## ORIGINATION FORM

Proposed Revisions to a Standard Plans Index  
(Please provide all information — Incomplete forms will be returned)

Index Number: 654-001  
Sheet Number (s): 1 of 1  
Index Title: Rectangular Rapid Flashing Beacon Assembly

DETAIL "A"

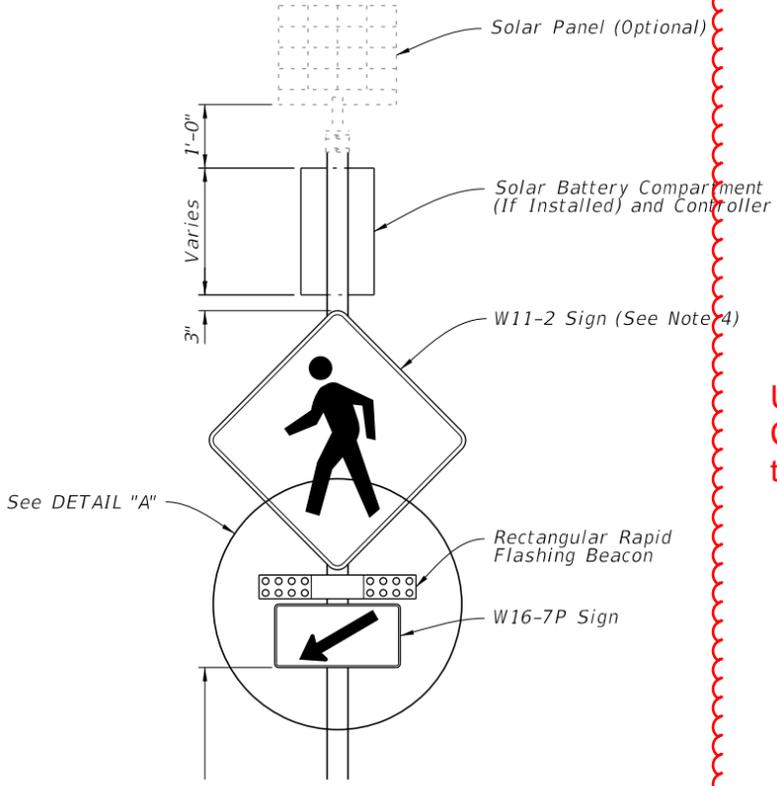
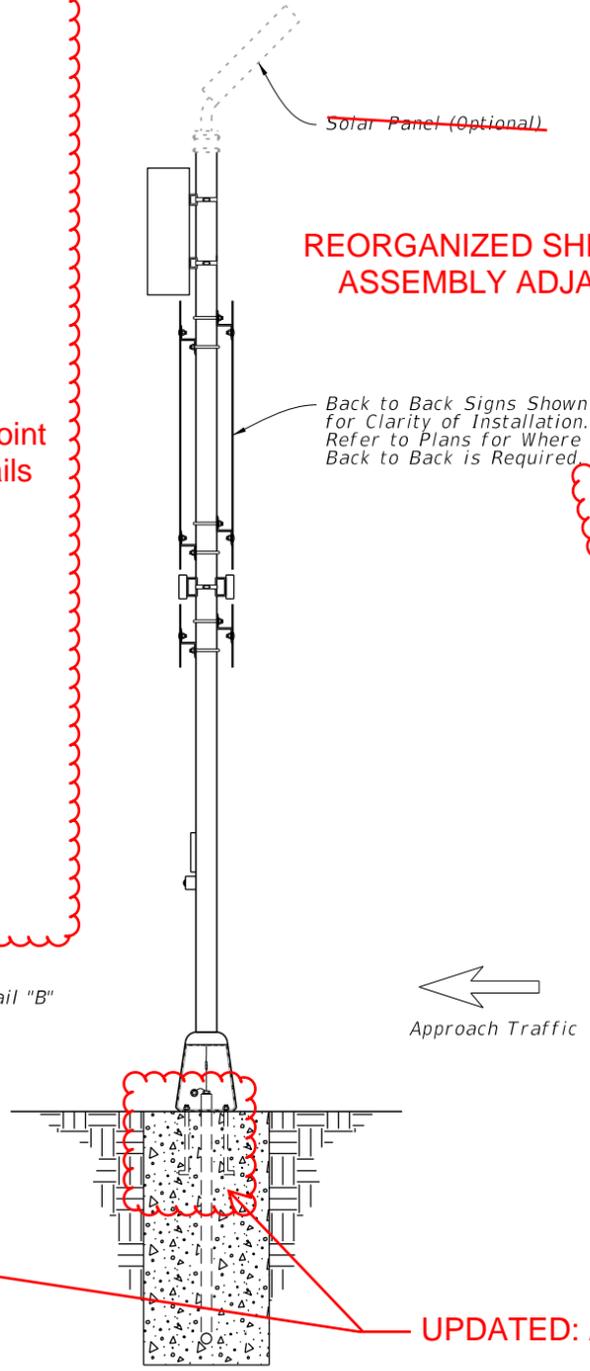
1. A transformer base is required for both conventionally-powered and solar-powered applications (conventional power shown).
2. Install the RRFB in pairs, one on either side of approach traffic.
3. Install controller on the back **CHANGED NOTE 1: to reference Index 700-102**
4. Install a 30" X 30" W11-2 sign 36" X 36" W11-2 sign for mu.
5. Install push button and FTP-68C-21 sign in accordance with Index 665-001.
6. Engage all threads on the transformer base and post unless the aluminum post is fully seated into base.

7. Meet the requirements of Specification 646 for ~~aluminum poles and transformer bases.~~ **CHANGED NOTE 4**
8. Install a concrete slab around all pull boxes. The minimum slab dimension is 4'-0" by 4'-0". In urban areas where space is limited slab dimensions may be adjusted as shown in the Plans.
9. For assemblies connected to conventional power, provide single pole non-fused watertight breakaway electrical connectors in the frangible transformer base.
10. When wire entry holes are drilled in the sign column, use a bushing or rubber grommet to protect conductors.
11. For solar-powered applications, orient solar panel to face South for optimal exposure to sunlight.

**REORGANIZED SHEET TO SHOW BEACON ASSEMBLY ADJACENT TO SIDEWALK**

SIDE VIEW

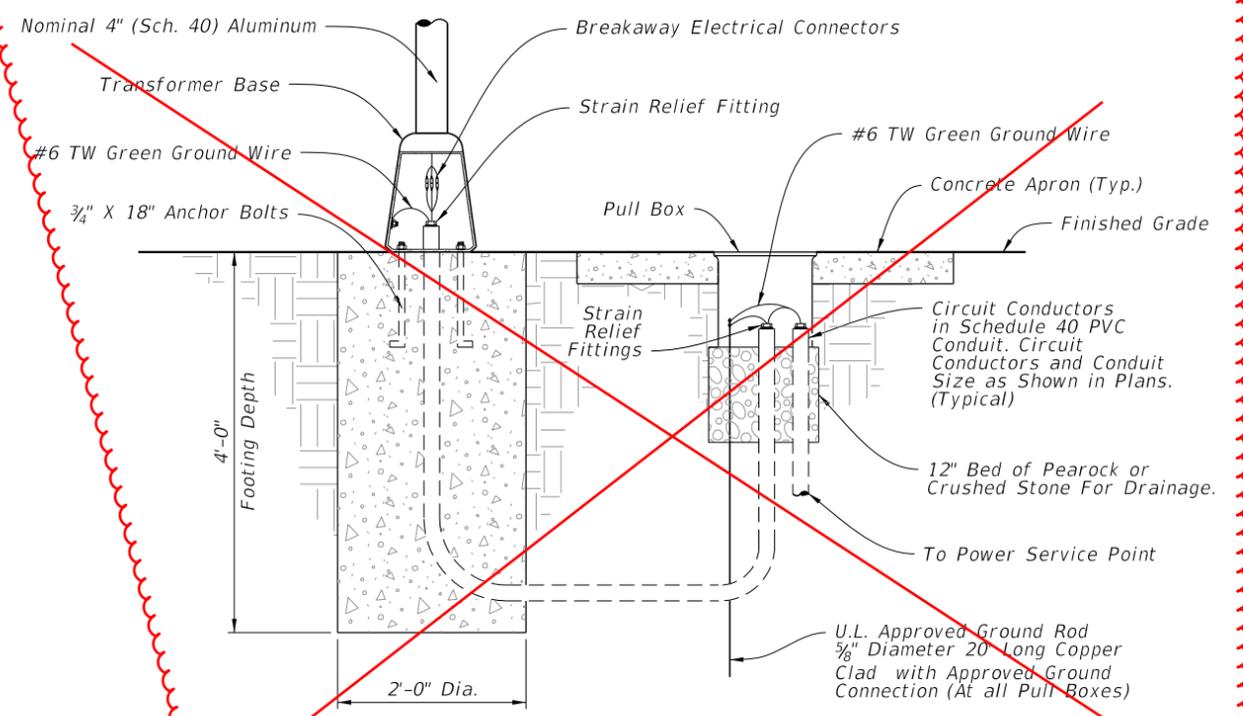
**UPDATED: Callout to point to both details**

DETAIL "B"

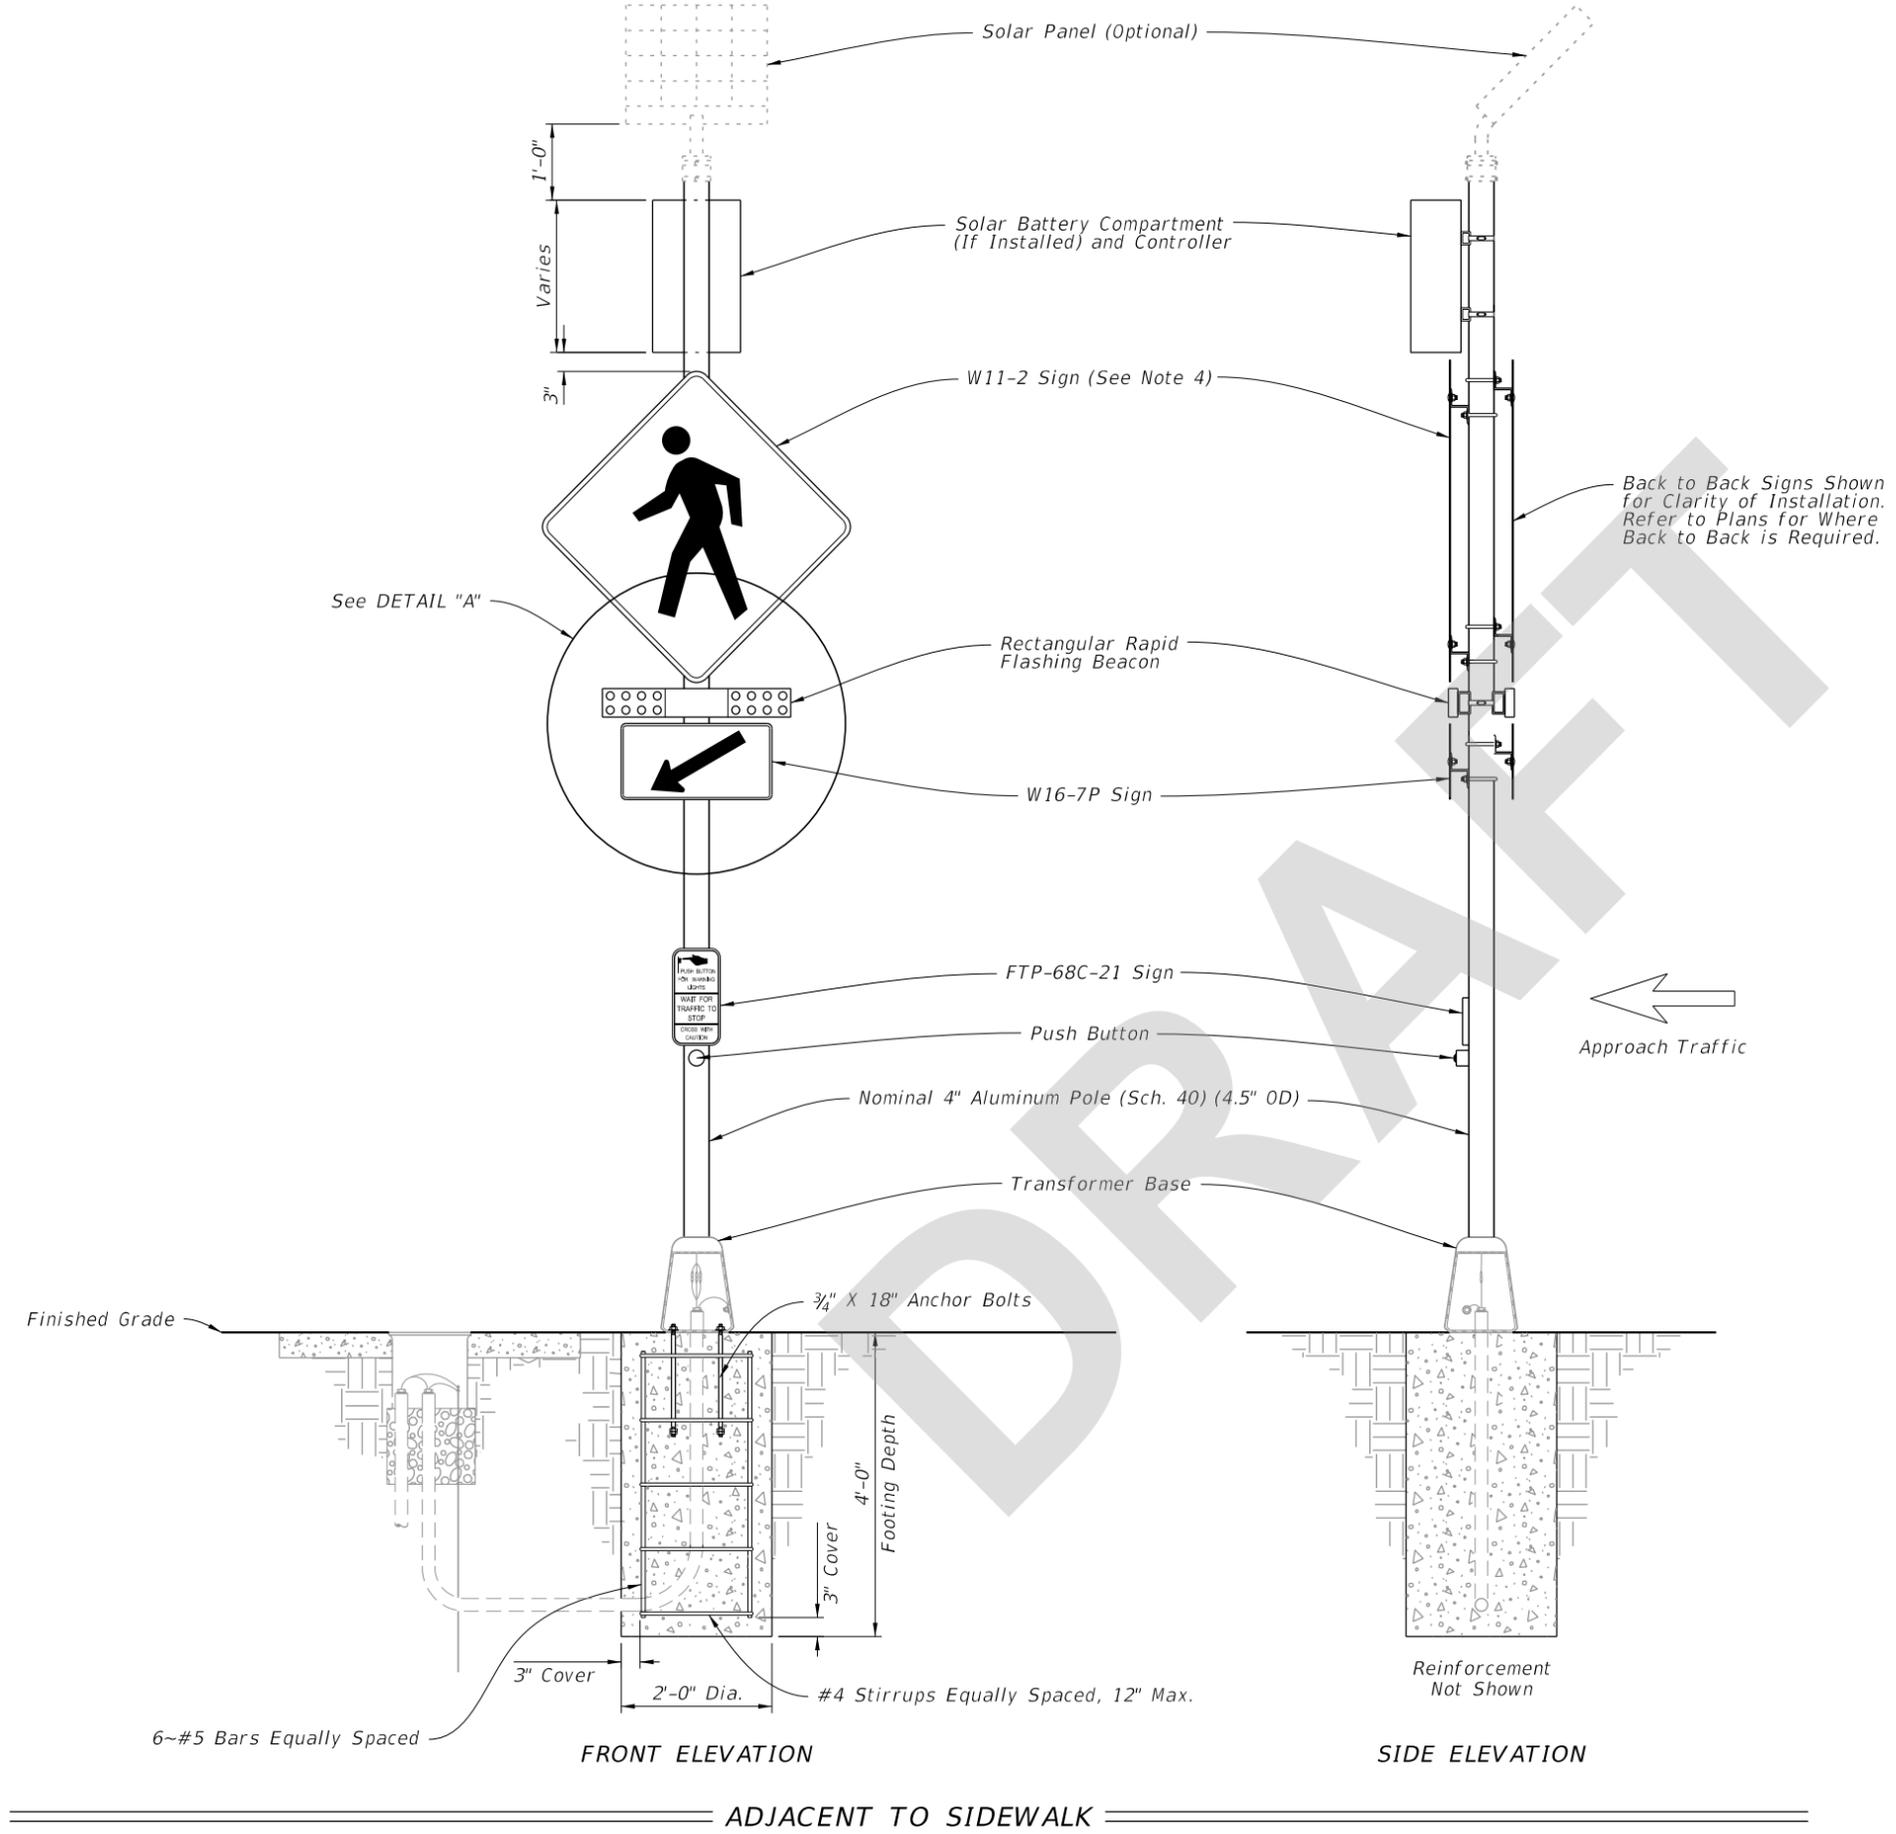
**DELETED DETAIL "B" AND ADDED REFERENCE TO INDEX 700-120 NOTE 1.**

**UPDATED: Anchor Bolts**

**CHANGED TO: Nominal 4" Aluminum Pole (Sch. 40) (4.5" OD)**

SHOWING BEACON ASSEMBLY IN SIDEWALK CURB

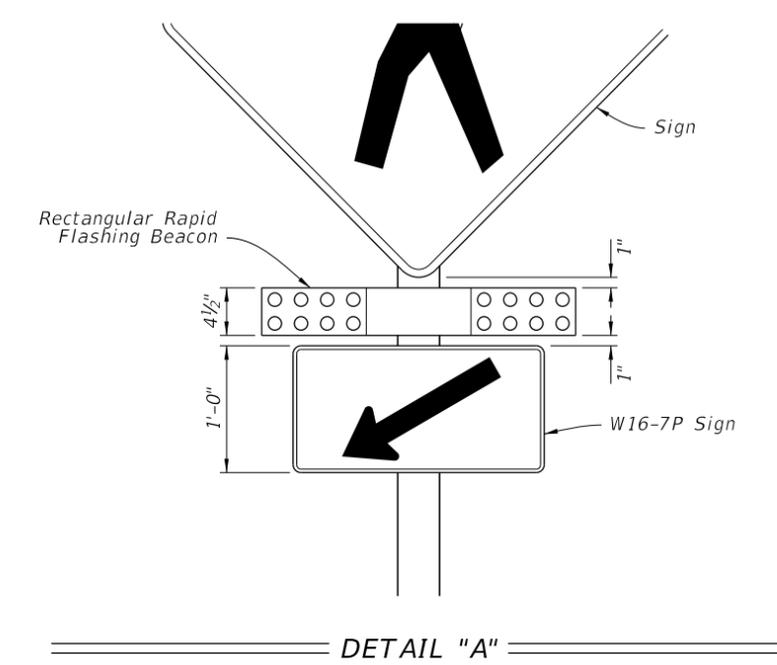
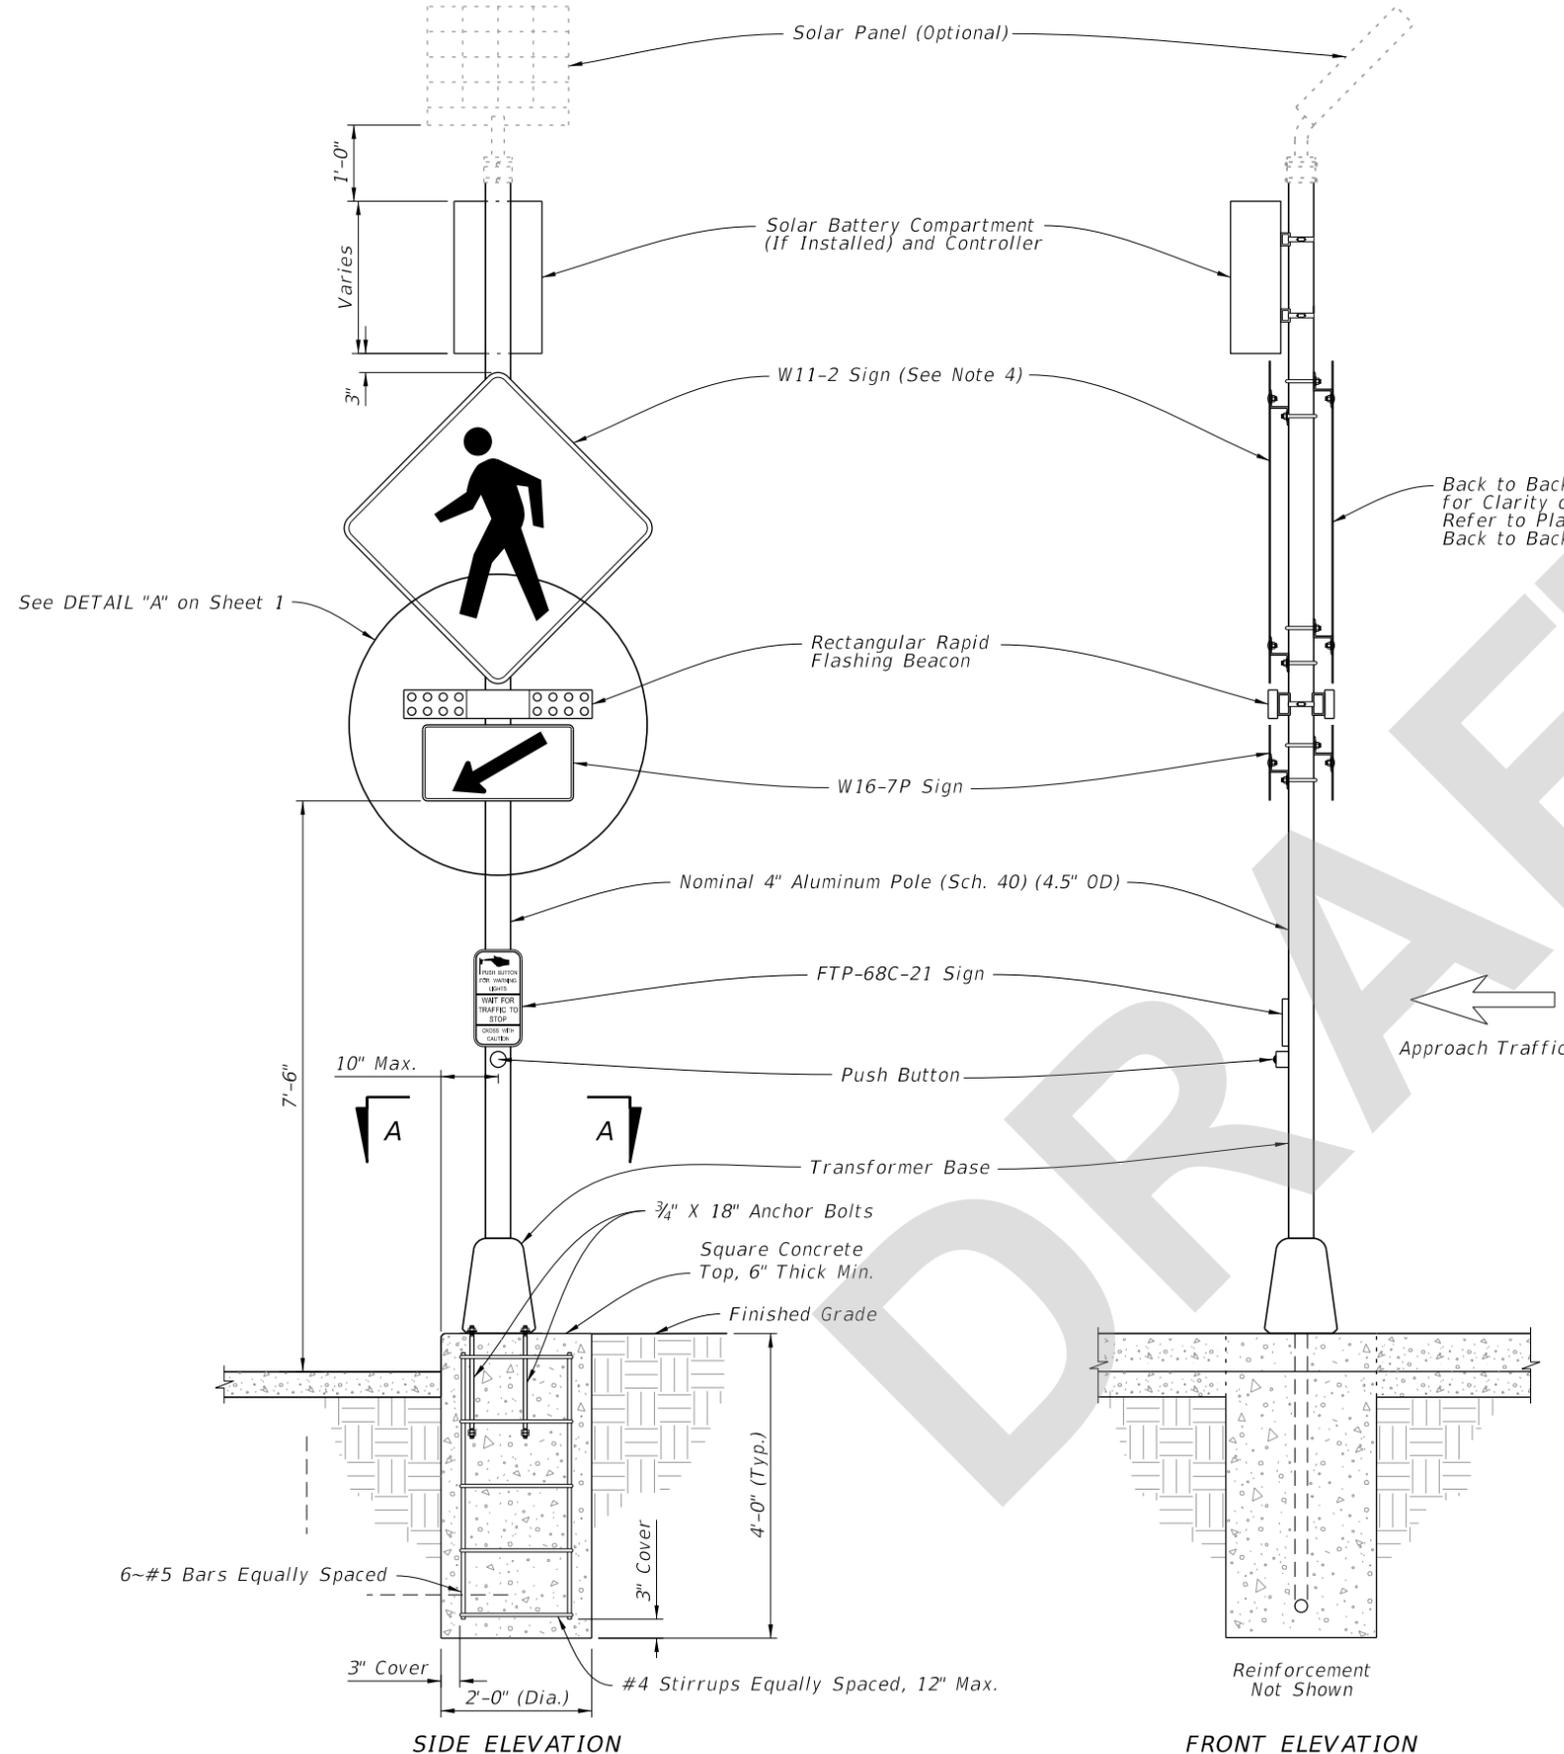
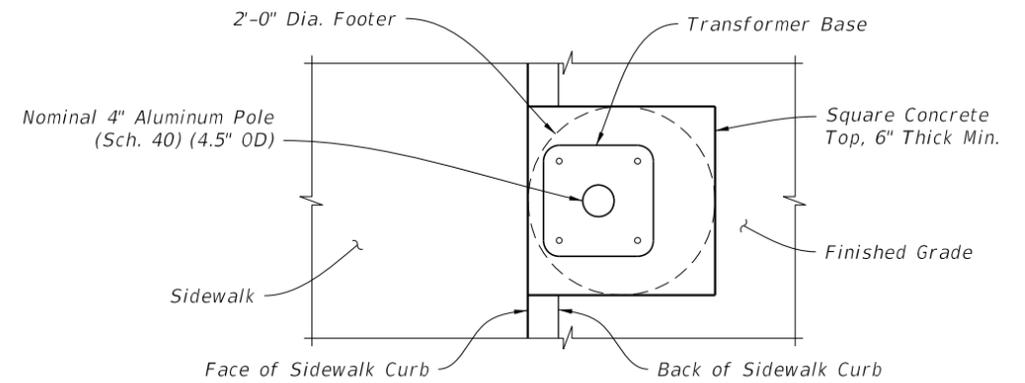
Sheet 2: (New Sheet) showing the Beacon Assembly in the Sidewalk Curb.

# NEW SHEET

1. A transformer base is required for both conventionally-powered and solar-powered applications. Install pull box, conduit, wiring, and grounding in accordance with Index 700-120 based on the powering configuration called for in the Plans.
